Re: Environmental Statement Statement of Conformity – Station Hill, Reading Phase 3

Proposed Section 96a Outline Parameter Amendments - October 2025 Amendments

Table 1: New Parameter Plans

category	0 GENERAL
family	010000-019999 TOWN PLANNING
title	02 DAS and ES EIA Consolidated Plans Plots (For Environmental Statement)

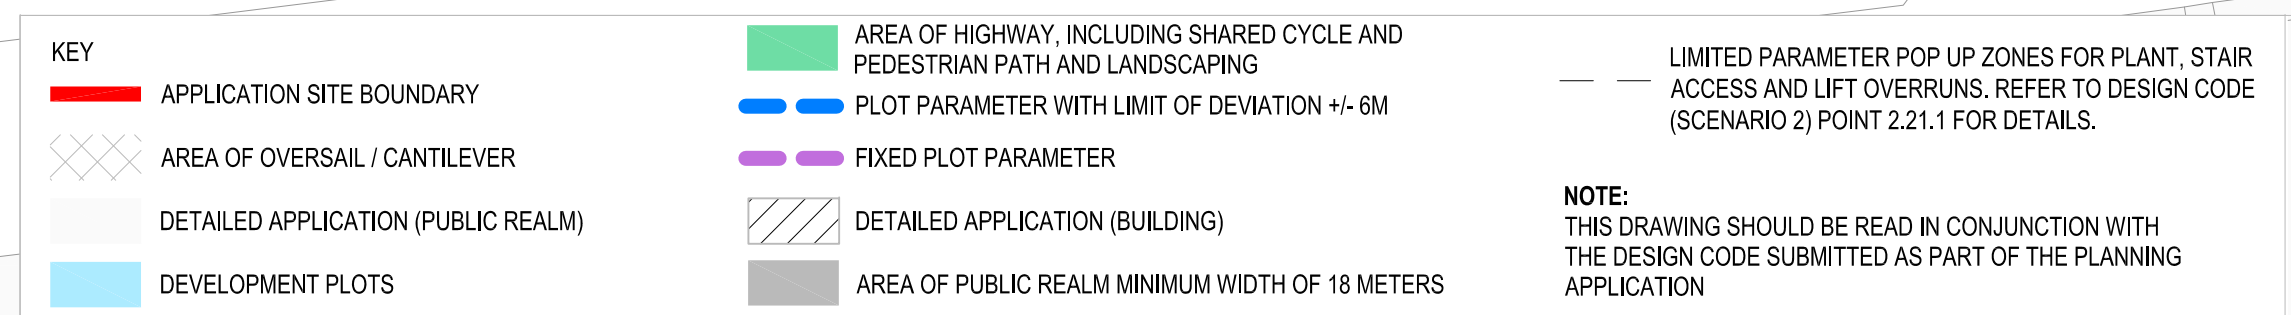
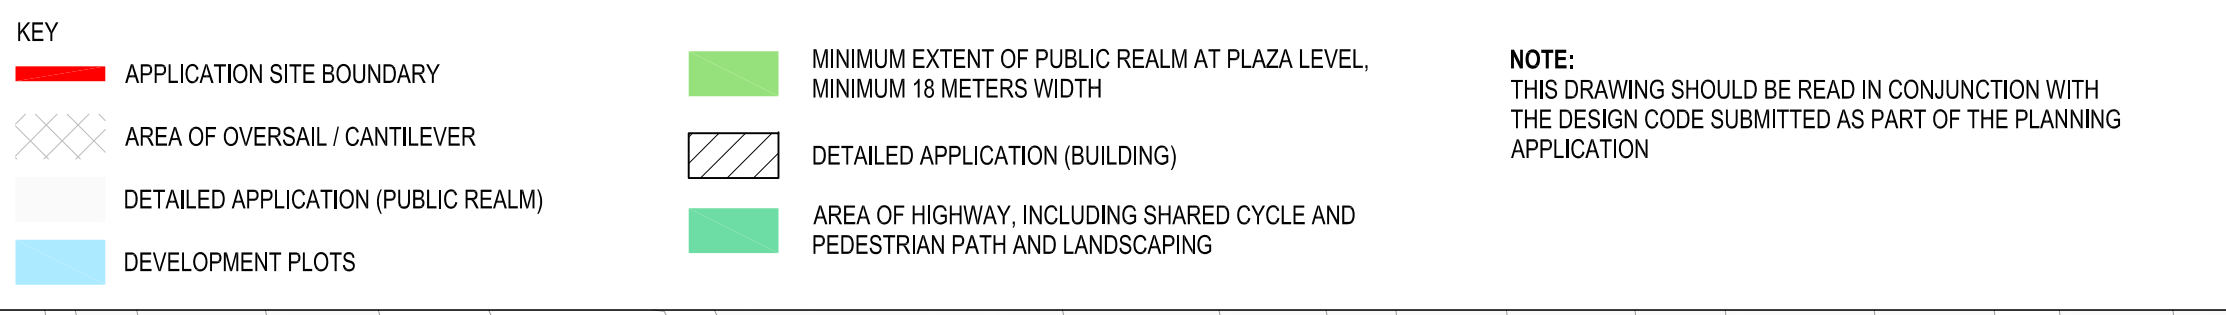
Drawing Title/ Ref	Reference	Amendments to Parameter Plans compared to the consented scheme
02 DAS and ES EIA Consolidated Plans Plots (For Environmental Statement)	A-0254b-P00	• 18m Gap introduced between Plot B and D • Access removed from Greyfriars to Public Realm • Shoulder removed to Plot D for 1 consistent parameter limit of +116.5m
07 Parameter Plans Phase 3: Outline Planning Application Plots	A-0705n-P00	• 18m Gap introduced between Plot B and D • Access removed from Greyfriars to Public Realm • Shoulder removed to Plot D for 1 consistent parameter limit of +116.5m • Lift / Stair / Plant pop up zone dashed line added to plan
07 Parameter Plans Phase 3: Outline Planning Application Public Realm and Pedestrian Access Plaza Level	A-0710b-P00	• 18m Gap introduced between Plot B and D • Access removed from Greyfriars to Public Realm • Shoulder removed to Plot D for 1 consistent parameter limit of +116.5m

project				
Station Hill, North				
Reading				
project number		drawn		checked
08.8531.000		EF		JB
scale		date of first issue		rev
1 : 500@A1		21/10/25		P00
project code	originator	functional spatial	form	discipline number
SHP3 - GEN - ZZ - ZZ - D - A-000711

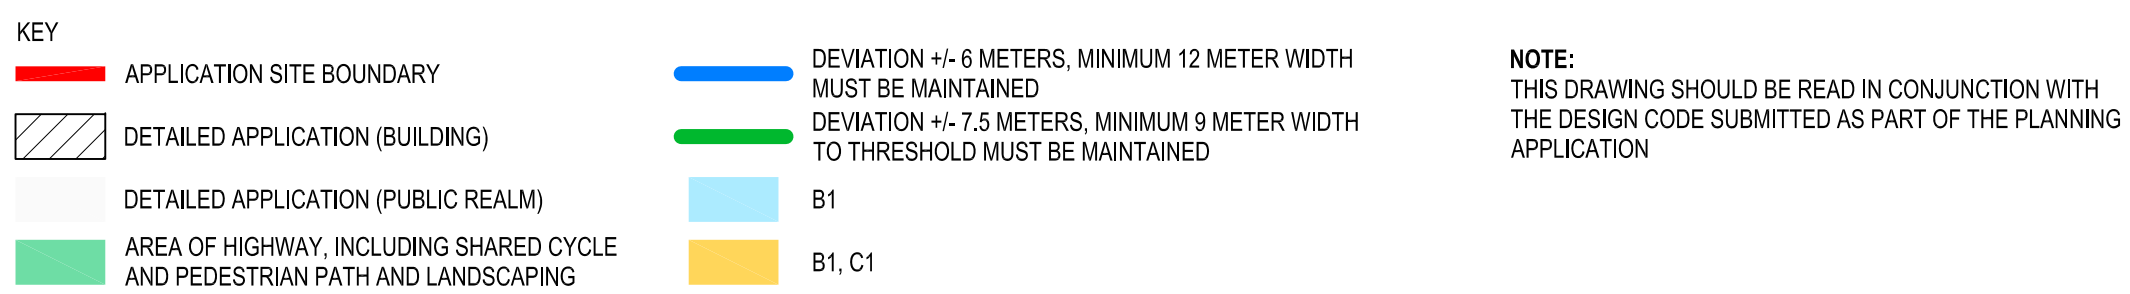
07 Parameter Plans Phase 3: Outline Planning Application Land Use and Minimum Distance Between Plots Plaza +2 and Above Mixed Use Scheme	A-0711b-P00	• 18m Gap introduced between Plot B and D • Shoulder removed to Plot D for 1 consistent parameter limit of +116.5m • +/- 6m deviation line amended to suit gap between plot B and D
07 Parameter Plans Phase 3: Outline Planning Application Land Use and Minimum Distance Between Plots Plaza +2 and Above All Commercial Scheme	A-0712b-P00	• 18m Gap introduced between Plot B and D • Shoulder removed to Plot D for 1 consistent parameter limit of +116.5m • +/- 6m deviation line amended to suit gap between plot B and D
07 Parameter Plans Phase 3: Outline Planning Application Vehicular Access and Servicing	A-0715b-P00	• 18m Gap introduced between Plot B and D • Shoulder removed to Plot D for 1 consistent parameter limit of +116.5m • Zone for vehicle access added off Garrard Street into Plot D.

Figure 1: Comparison of the massing for Phase 3

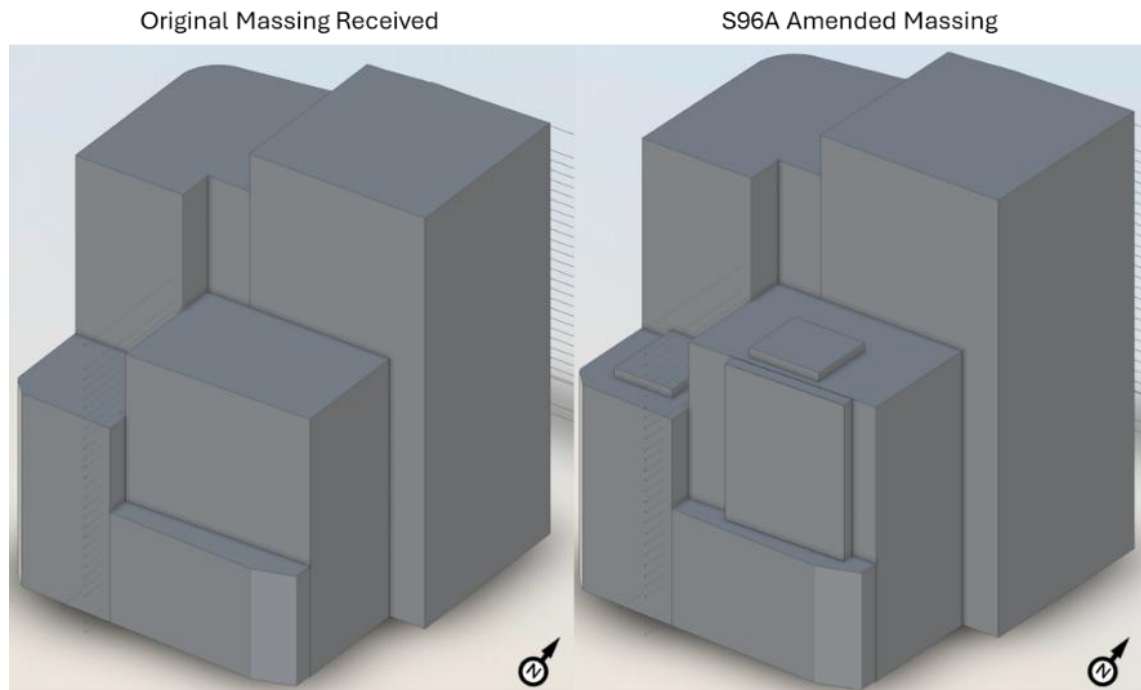
Since the 2019 assessment, the massing for Phase 3 has been amended. The changes include:

- The additional massing on the southern side of Garrard Street;
- The removal of the shoulder on Greyfriars Street; and
- The addition of the plant area “pop ups” on the tops of the buildings.

A comparison between the original massing received and the S96A amended massing show that the massing changes would be minor in nature, including additional massing on the southern side. This can be seen in Figure 1. Given the minimal nature, these amendments would not be expected to introduce new significant wind effects. The same conclusions reported in the consented assessment would remain. Furthermore, windy areas around Phase 3 will be resolved in future testing to support the RMA, and to confirm suitable wind conditions, with mitigation measures developed as necessary.
